Unit D North Bank Road, Port Talbot

Transport Note

Document Reference: **C24120/TN01**

- 1.1.1 Apex Transport Planning (“Apex TP”) has prepared this Transport Note (TN) to provide further information in response to comments provided by the highway authority, Neath Port Talbot County Borough Council (NPTCBC), in relation to the planning application (reference: P2024/0212). The application is for the construction of industrial unit comprising 4 no. self-contained units, with unit 1-2 operating as a class 7 MOT centre for vans and cars, and units 3-5 for B2 or B8 use class, on land off North Bank Road, Port Talbot, SA13 1RE.

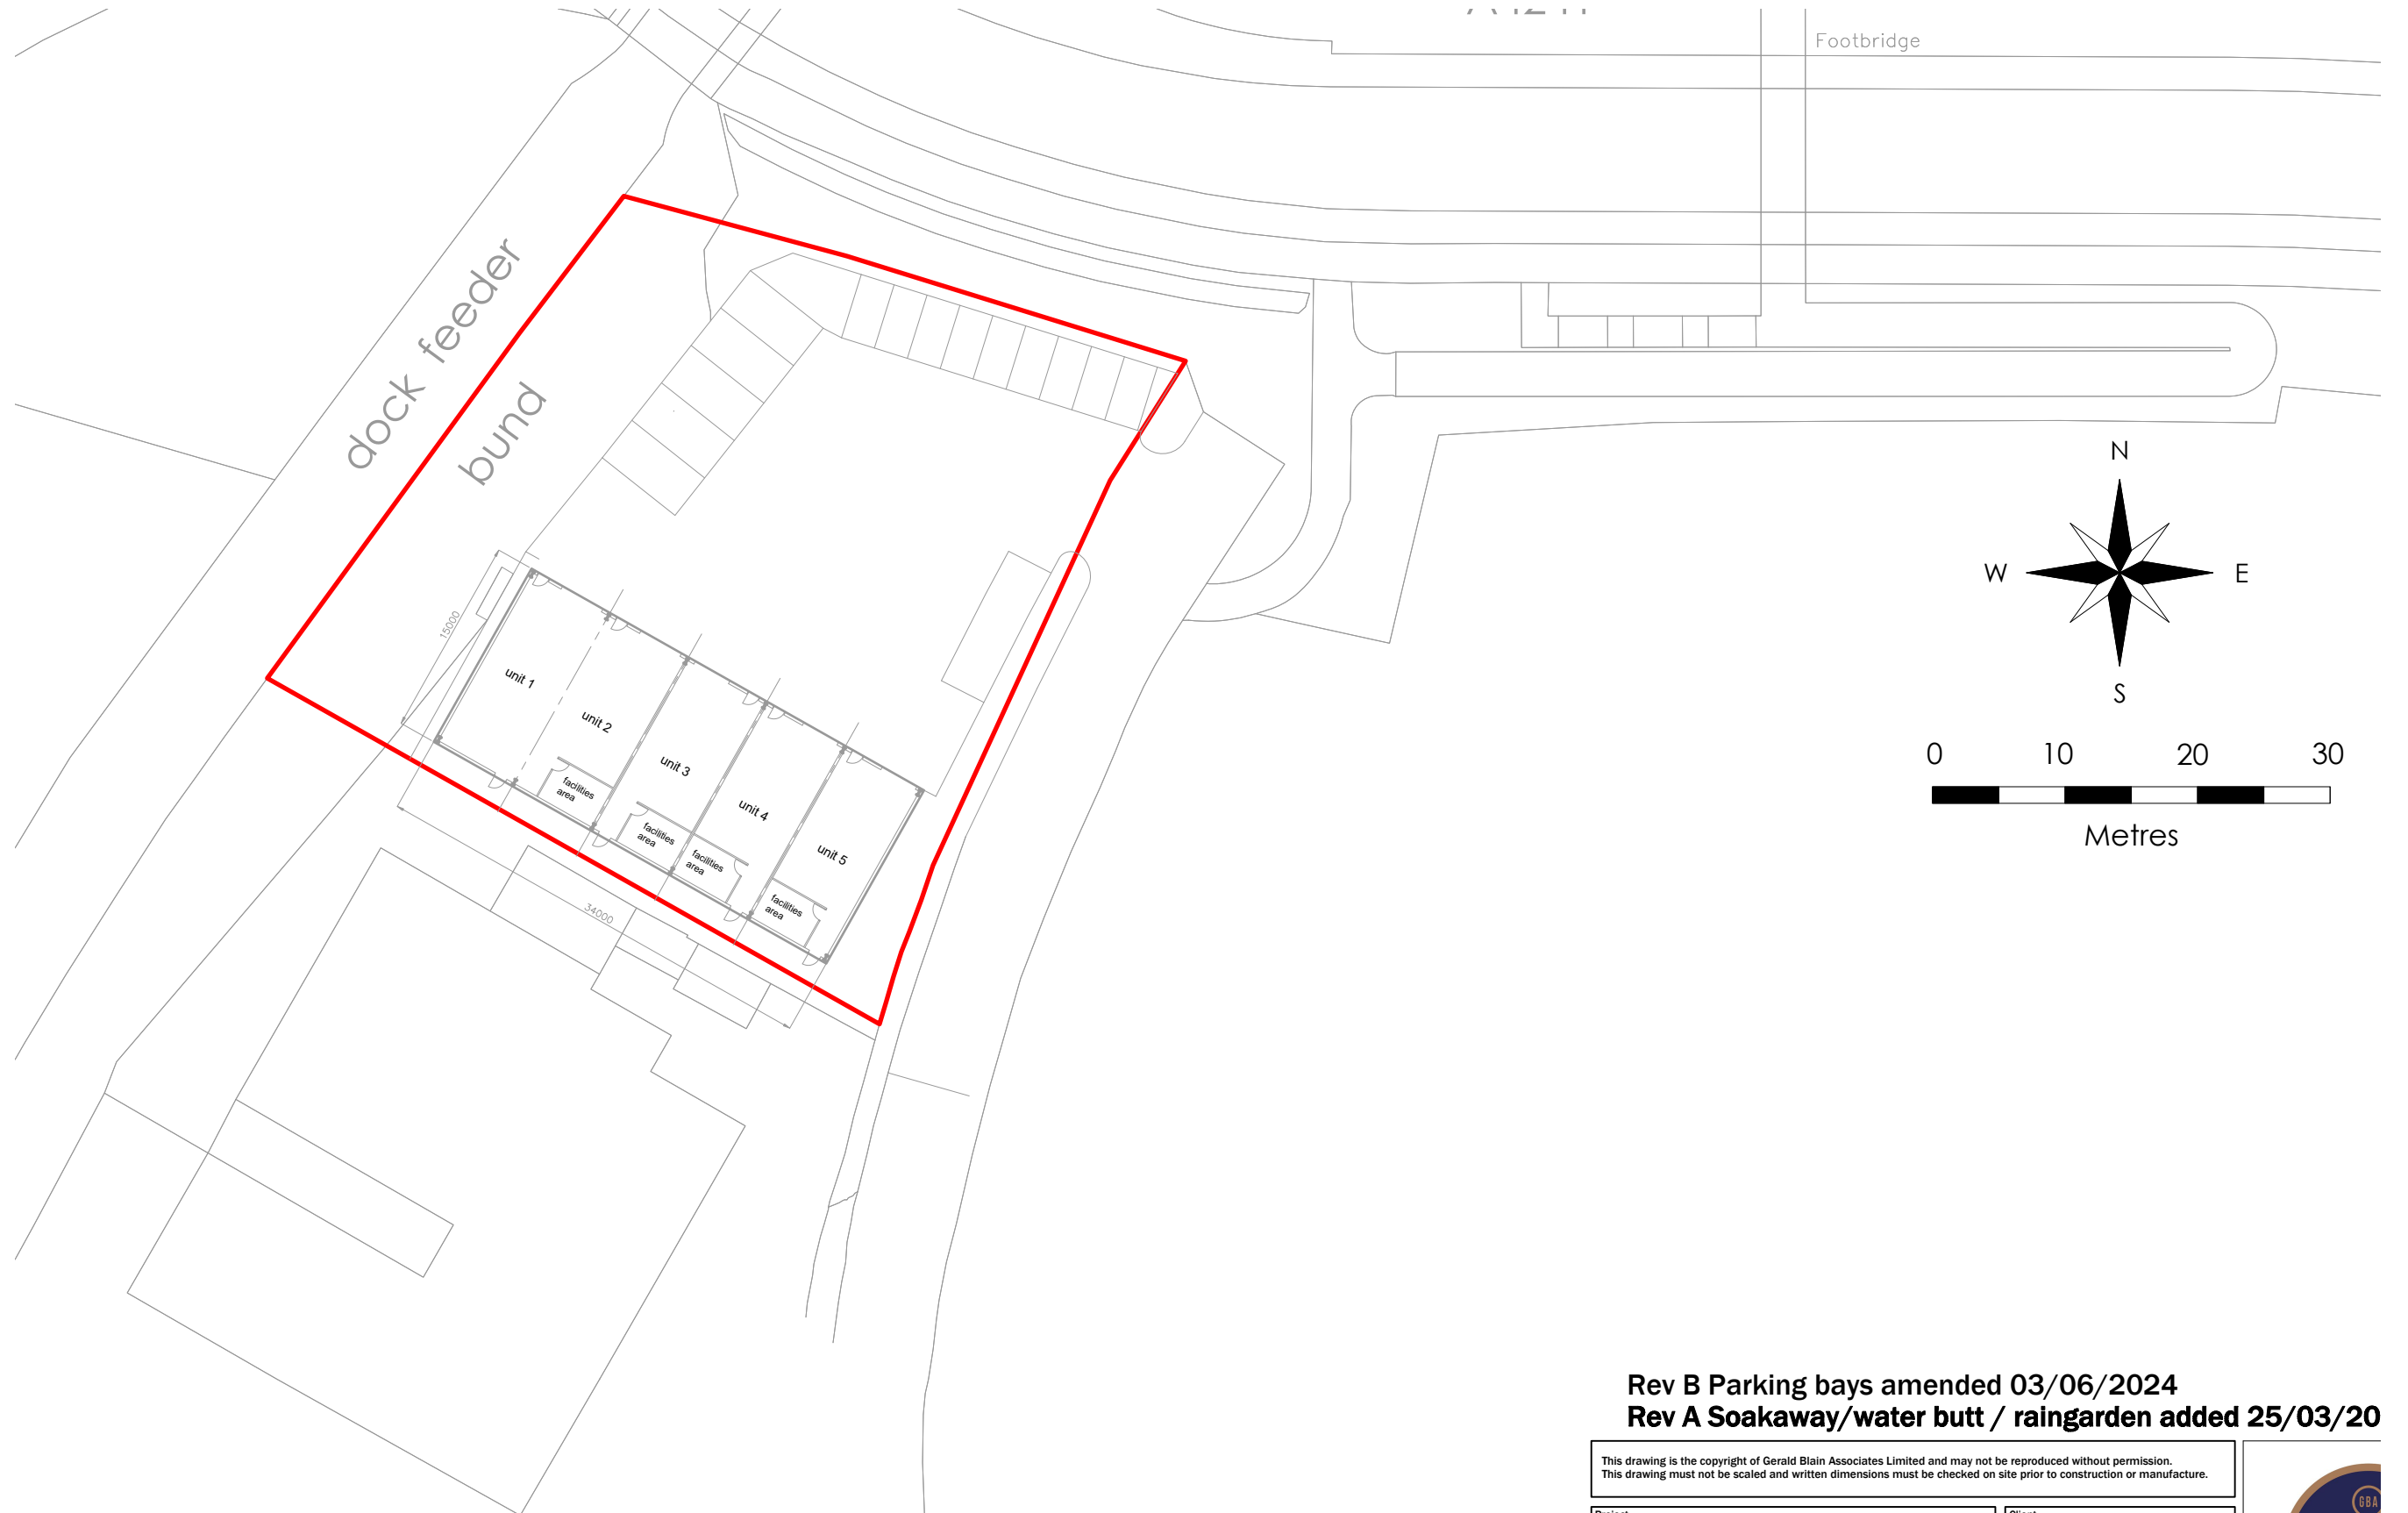
1. Vision splays should be annotated on a suitably scaled drawing in accordance with TAN 18. It appears the vision splays have been drawn in accordance with Manual for Streets which only applies to streets.
2. What is the largest vehicle that will service the development?
3. Vehicles servicing/loading at the easternmost unit will conflict with vehicles using the access point to the site. The unit should be moved away from the access to improve this. Where will vehicles servicing units 3-5 park when

loading/unloading? If the units are used for distribution (B8) then they need 35% of the GFA available for loading/unloading in accordance with our standards.

4. Will the development be gated? Gates should open inwards, be see-through and shown on the submitted drawings. It appears from the drawing that any inwards opening gates would conflict with the easternmost unit.
5. Parking for the M.O.T centre element should be 1 lorry space (with 20% of the GFA of the M.O.T centre around it for loading/unloading) and 2 car/LGV spaces per service bay in accordance with our SPG Parking Standards (Oct 16).

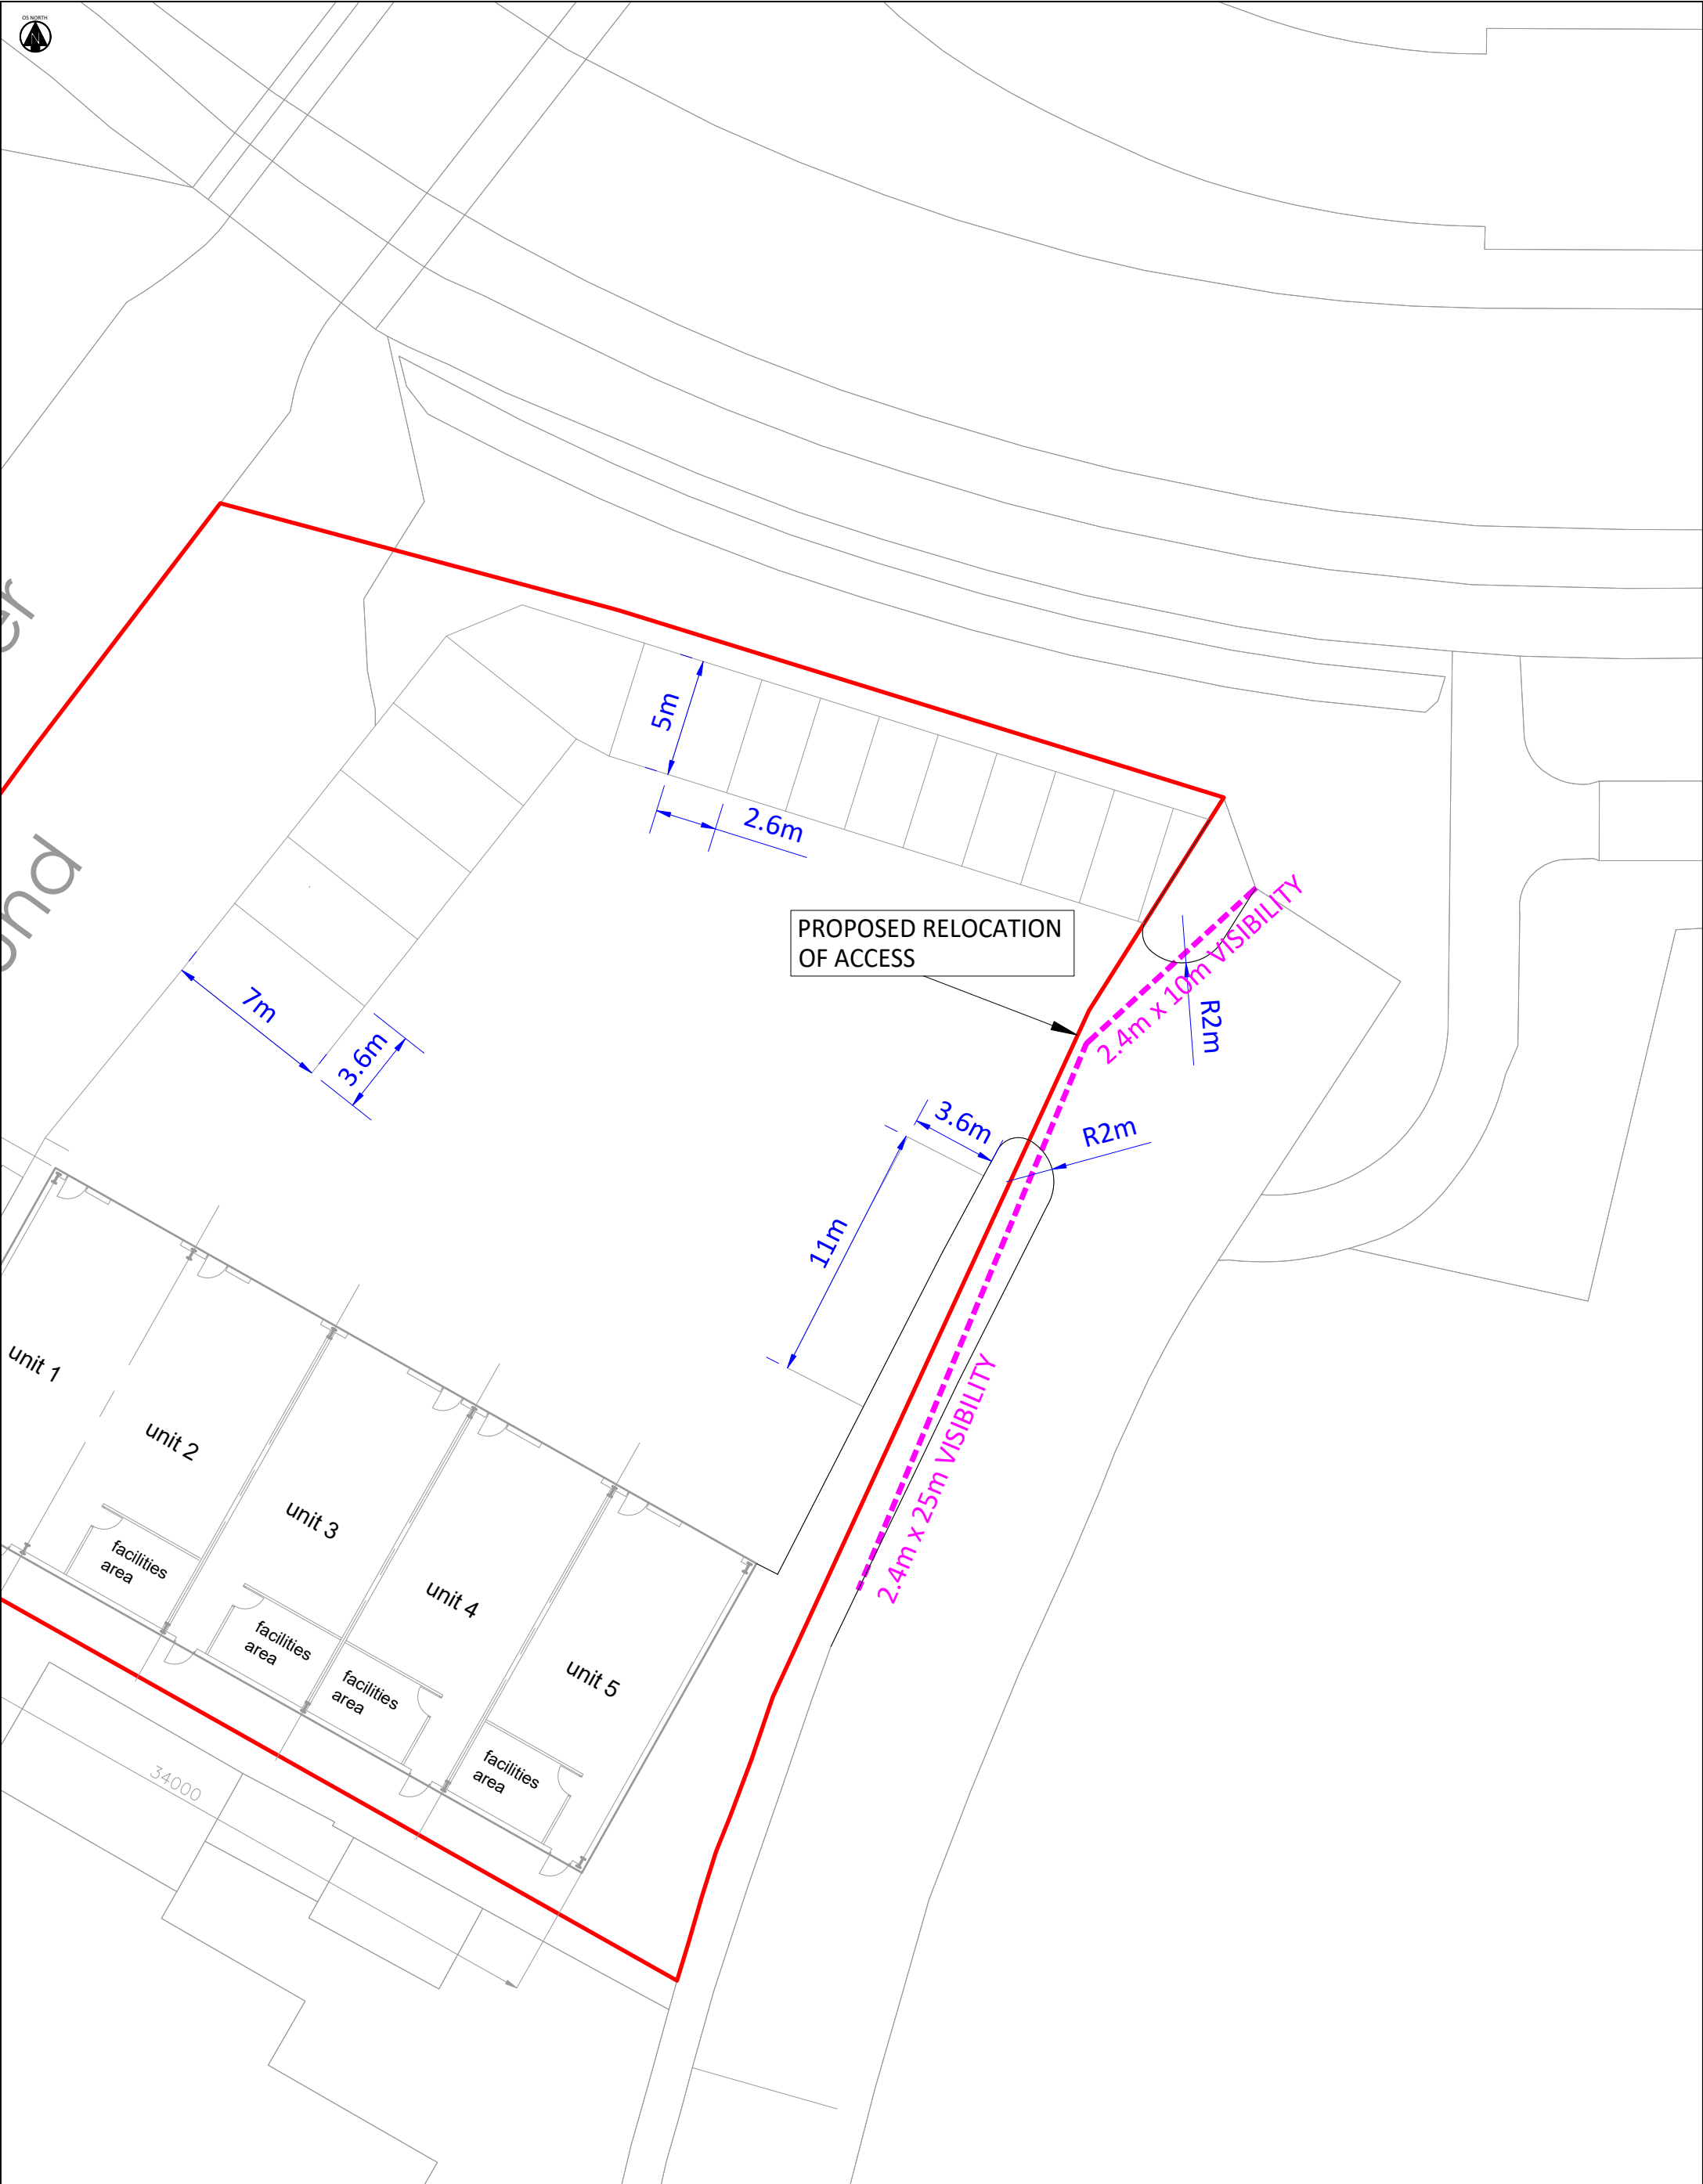
“Vehicles servicing/loading at the easternmost unit will conflict with vehicles using the access point to the site. The unit should be moved away from the access to improve this. Where will vehicles be servicing units 3-5 park when loading/unloading? If the units are used for distribution (B8) then they need 35% of the GFA available for loading/unloading in accordance with our standards.”

“Will the development be gated? Gates should open inwards, be see-through and shown on the submitted drawings. It appears from the drawing that any inwards opening gates would conflict with the easternmost unit.”

- 4.1.1 The conflict between vehicles servicing/loading at Unit 5 and vehicles using the access point to the site has been considered within the revised site layout and access arrangements. The site access has been relocated to the north to avoid any potential conflict and remove any safety concerns. The proposed general access arrangement design is shown on drawing C24120-ATP-DR-TP-0001 (attached at Appendix B).
- 4.1.2 All units can be accessed via an LGV, as shown in the swept path analysis drawing attached at Appendix D. The LGV parking spaces can also accommodate vehicles whilst waiting for their MOT. No loading/unloading will take place from these spaces.

- 4.1.3 The development will not be gated. Please see the revised layout attached as Appendix B.

- 5.1.2 The revised layout arrangement provides more space for vehicle manoeuvring around the site, as well as space in front of each unit for manoeuvring. When required a LGV can also stop outside the frontage of each unit – i.e. for short term deliveries, or for operational purposes when moving vehicles into and out of each service bay. As such, the revised layout provides an improvement over the previous layout in this regard.
